# San Clemente Dam Seismic Safety Project

## Final Supplement to the EIR, No. 2 Old Carmel River Dam Removal

**SCH # 2012071036**

**August 2012**

## 4. MITIGATION MONITORING AND REPORTING PROGRAM

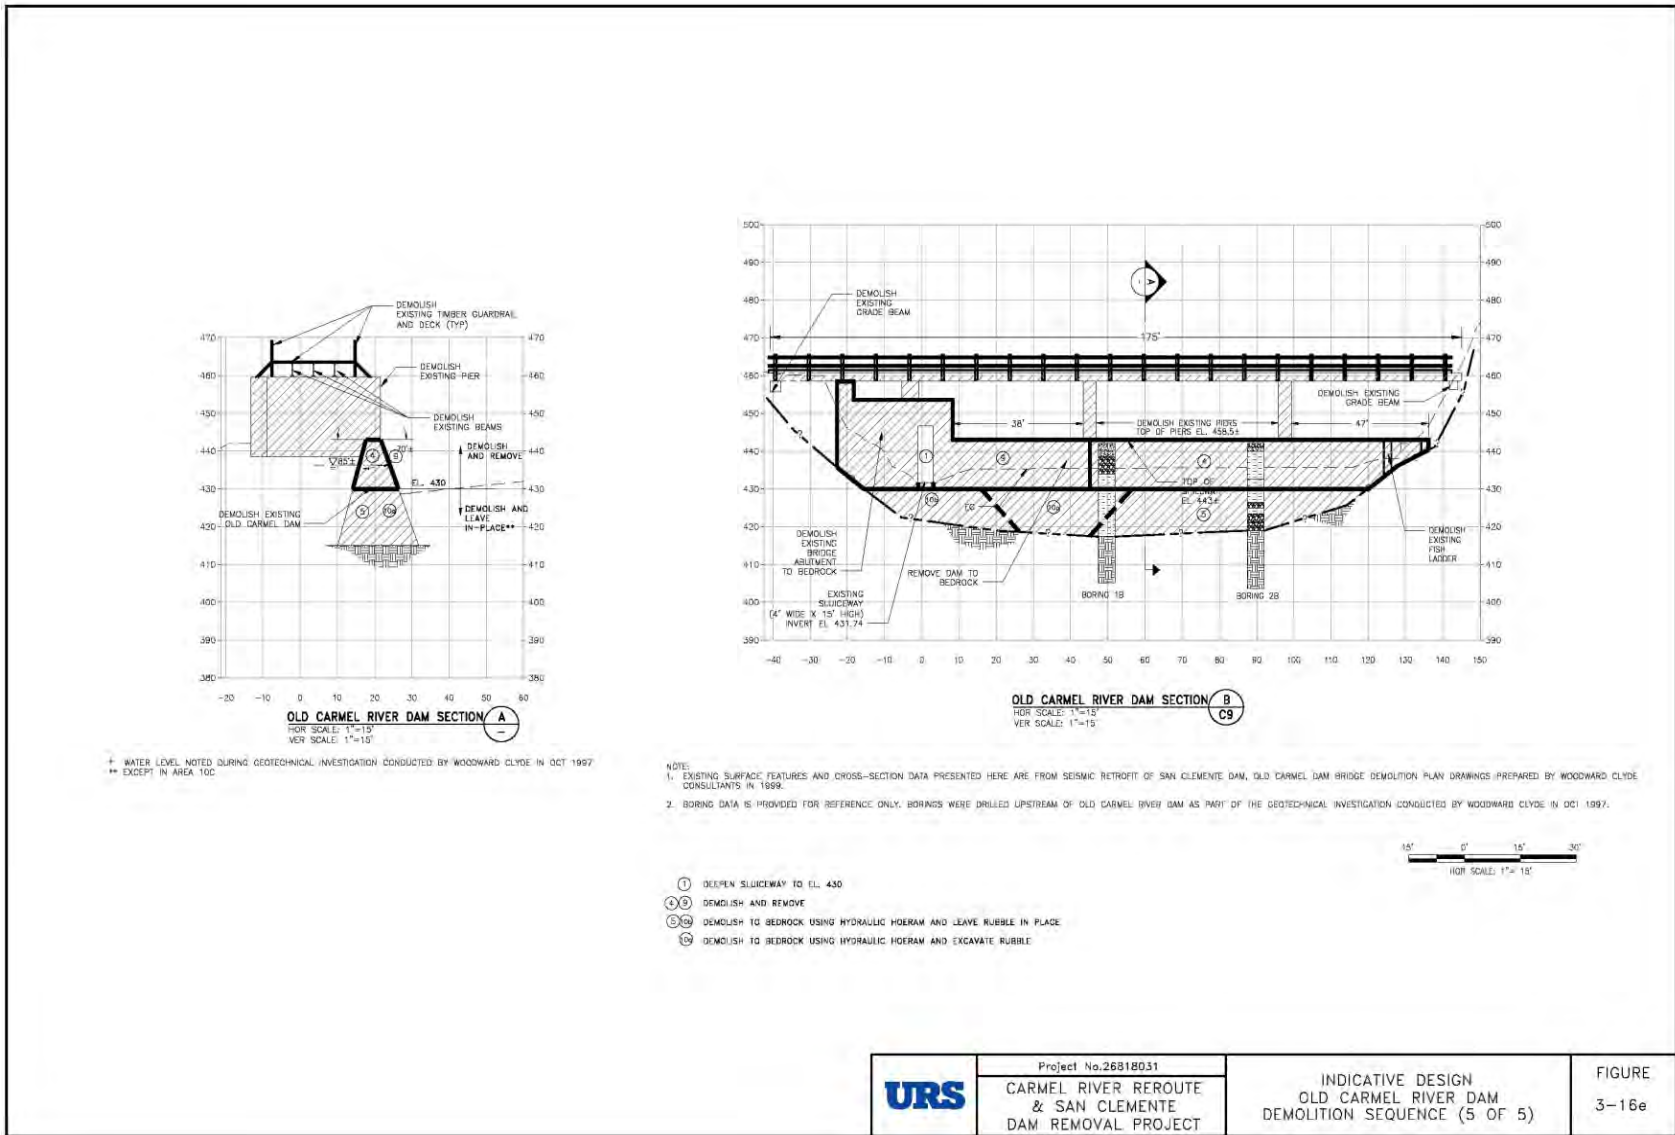
*Page 3-4 of the Second SEIR states that "It is not expected that engineered diversion facilities (e.g., sheet piles, coffer dams, etc.) would be necessary to contain the river flow in its current low flow channel (around the initial demolition work area); however, they may be used if needed." This description is too vague to allow meaningful analysis. The project description should clarify why such diversion facilities are considered unnecessary, and what conditions would warrant their use "if needed." If used, such facilities must be described and analyzed within the Second SEIR.*

Figure 3-4 a-e: Old Carmel River Dam Demolition Sequence has been attached as part of this response and is incorporated into this Final SEIR No. 2.
